drainage plat

OLD MISSION SERVICES ADD'N.

PROJECT: OLD MISSION SERVICES
ADD'N. JOB NO. _____
TO: CHRIS BEERTENSTEIN
FROM: B. HOOPER
REFERENCE: DRAINAGE PLAT

CONFIRMATION
MEMO

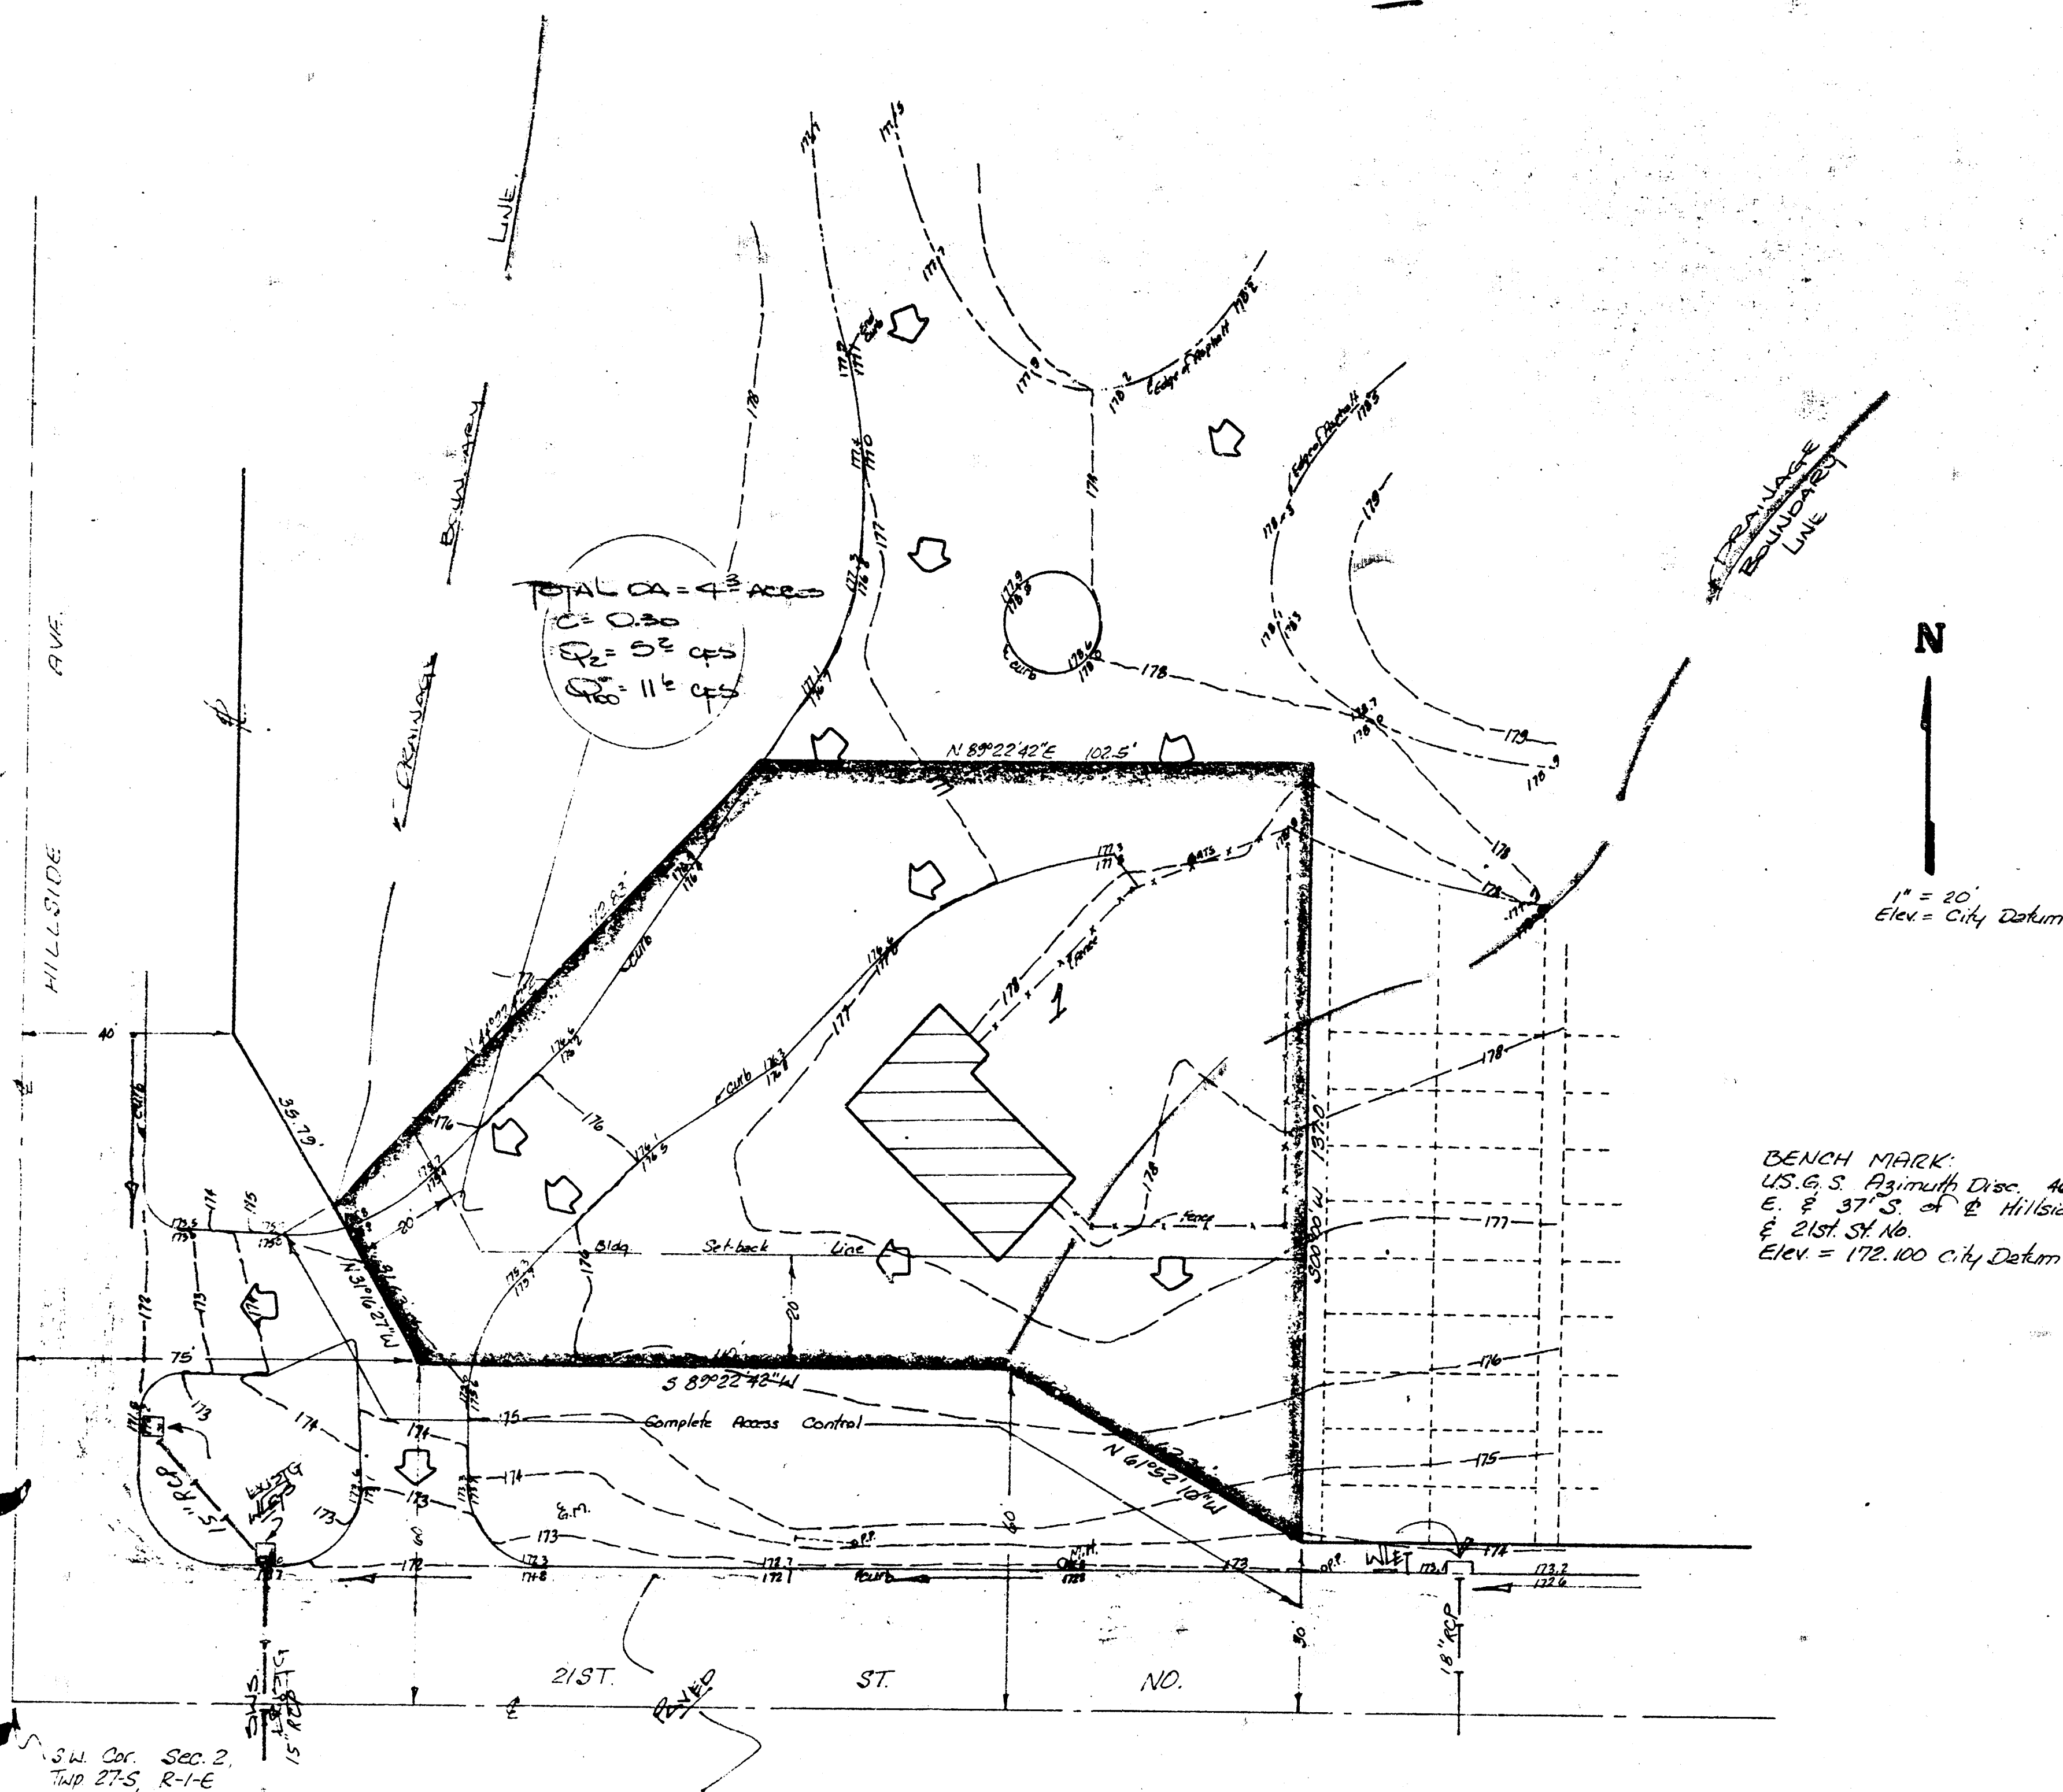
Final plat is scheduled for 11-10-83.
This plat is in a developed cemetery. Soil type is 4 - brown pine. Soil group is B. Runoff factor for outside drainage areas is 0.30. Discharge area into this plat & to 21st St. & Hillside is 4.3 ac. Floods are indicated.

If the driveway is removed which discharges onto 21st & Hillside both, 18" stubs pipe and inlet needs to be augmented to intercept the indicated flow. The necessary pipe size is 18" min. w. an equivalent of three drop inlets.
